TECHNICAL BULLETIN

021

January 2018

BACKUP RING PXI VAM 9.850-265.0 (old 000905)

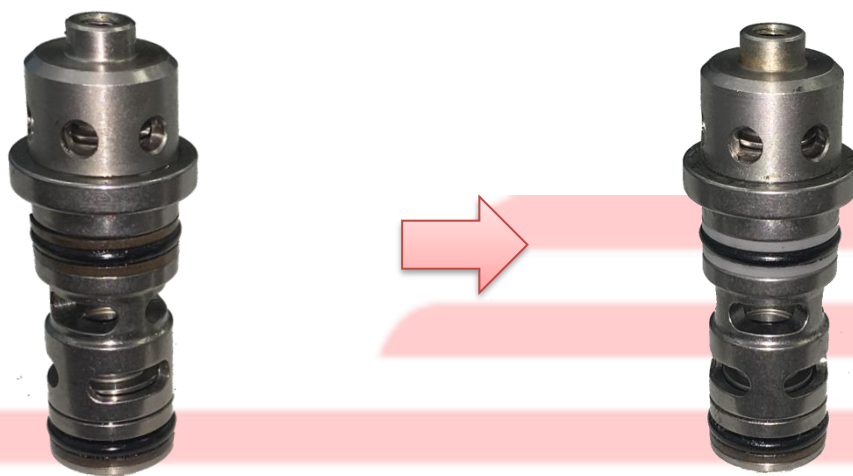
- *Modification of material on 2 backup rings 9.850-265.0 placed in the VAM center cartridge 1.099-704.0 (old 360407) and 1.099-703.0 (old 360406) of the PXI pumps;*
- *This new material improves significantly the durability of the O-ring between the 2 backup rings; visually the new backup ring is white*
- *The new backup ring is interchangeable with the previous one.*

ANTIETRUSORE VAM PXI 9.850-265.0 (vecchio 000905)

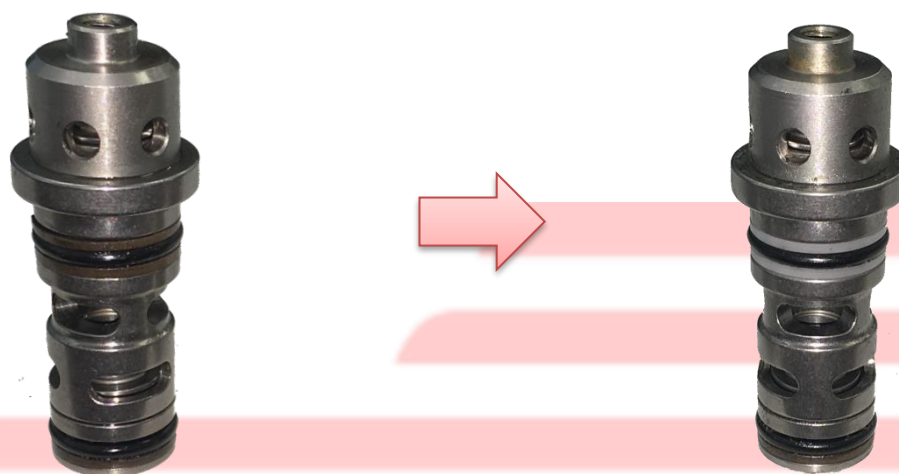
- E' stato cambiato il materiale dei 2 anti estrusore 9.850-265.0 posti in centro alla cartuccia VAM 1.099-704.0 (vecchio 360407) e 1.099-703.0 (vecchio 360406) delle pompa PXI
- Il nuovo materiale migliora sensibilmente la durata dell'anello OR incluso tra i 2 anti estrusori; visivamente il nuovo anti estrusore è di colore bianco
- Il nuovo anti estrusore è intercambiabile con il precedente.
